**Addendum 47: Regulation No. 48**

**Revision 4 - Amendment 1**

**UNIFORM PROVISIONS CONCERNING THE APPROVAL OF VEHICLES  
WITH REGARD TO THE INSTALLATION OF LIGHTING AND LIGHT-  
SIGNALLING DEVICES**

Model A

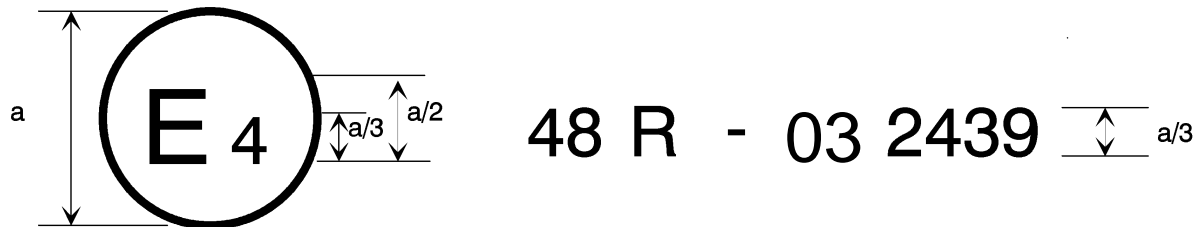
Annex 2, amend to read:

"Annex 2

ARRANGEMENTS OF APPROVAL MARKS

a = 8 mm min.

The above approval mark affixed to a vehicle shows that the vehicle type concerned has, with regard to the installation of lighting and light-signalling devices, been approved in the Netherlands (E4) pursuant to Regulation No. 48 as amended by the 03 series of amendments. The approval number indicates that the approval was granted in accordance with the requirements of Regulation No. 48 as amended by the 03 series of amendments.

Figure 1

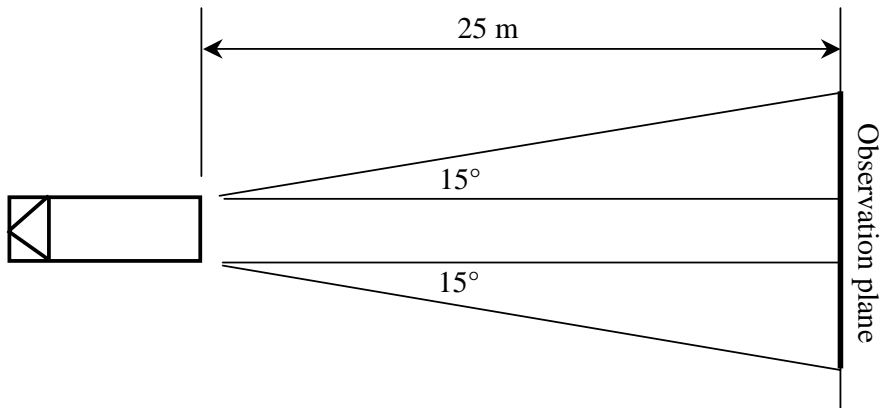
Insert a new Annex 11, to read:

VISIBILITY OF CONSPICUITY MARKINGS TO THE REAR AND  
SIDE OF A VEHICLE

6.21.5.1. for rear conspicuity markings (see Annex 11, Figure 1) the observation plane is perpendicular to the longitudinal axis of the vehicle situated 25 m from the extreme end of the vehicle and bounded by:

6.21.5.1.1. in height, by two horizontal planes 1 m and 3.0 m respectively above the ground,

6.21.5.1.2. in width, by two vertical planes which form an angle of 15° outwards from the vehicle's median longitudinal plane and which pass through the intersection of the vertical planes parallel to the vehicle's median longitudinal plane delimiting the vehicle's overall width, and the plane perpendicular to the longitudinal axis of the vehicle that delimits the end of the vehicle.
